Subject: AP1000 Response to Request for Additional Information (SRP6.2.2)

AP1000 TECHNICAL REPORT REVIEW**Response to Request For Additional Information (RAI)**

RAI Response Number: RAI SRP6.2.2-CIB1-28: Concrete as a Debris Source
Revision: 2

Figure A-1: DR post-blowdown damage to concrete structures within blowdown compartment (Figure C-3 of NUREG/CR-0897, Revision 1)

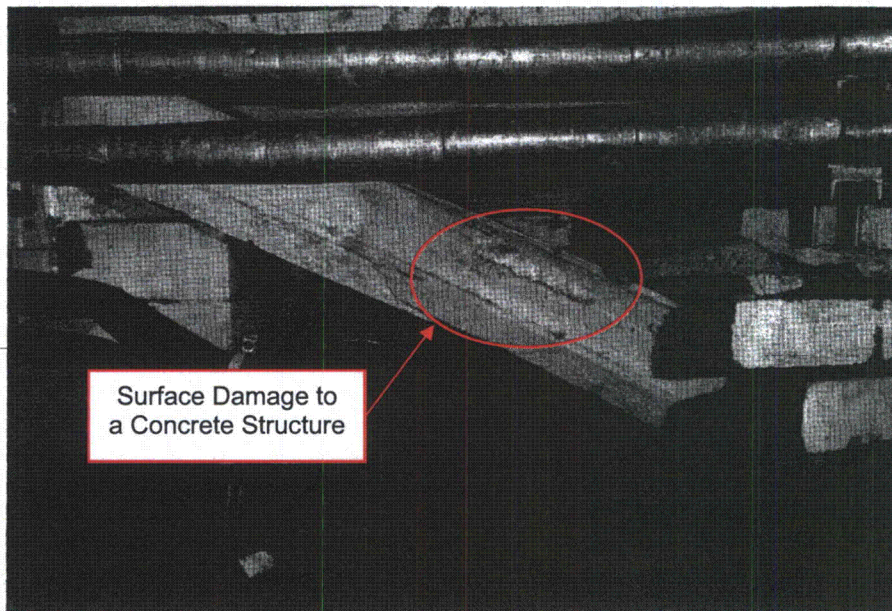
1. During its review, the staff found that NUREG-0897, Rev. 1, "Containment Emergency Sump Performance," March 1985, shows spalled concrete attributed to thermal shock. The damage occurred during a blowdown test in the German HDR facility. It's not clear how much of the debris was transportable, fine particles. The April 26, 2010, response, addressed jet temperature, but it was not clear that thermal shock was considered. Please discuss how you addressed the possibility of transportable debris generated by thermal shock.

- c) Figure A-1, Figure A-2, and Figure A-3 are photographs of the HDR facility inspections performed following the blowdown tests that identify damaged concrete. Figure A-1 shows limited surface damage to concrete structures within the blowdown compartment. Figure A-2 shows apparent damage at the corners of a concrete stairway in a compartment near the HDR blowdown chamber. Figure A-3 shows spalled concrete from the stairwell located near the blowdown compartment. Collectively, Figure A-2 and Figure A-3 show that the spalled concrete in HDR was in the form of large pieces several inches in length and width. From the size of the doorway shown in Figure A-3, the concrete debris in the HDR test facility is estimated to be several inches in size.
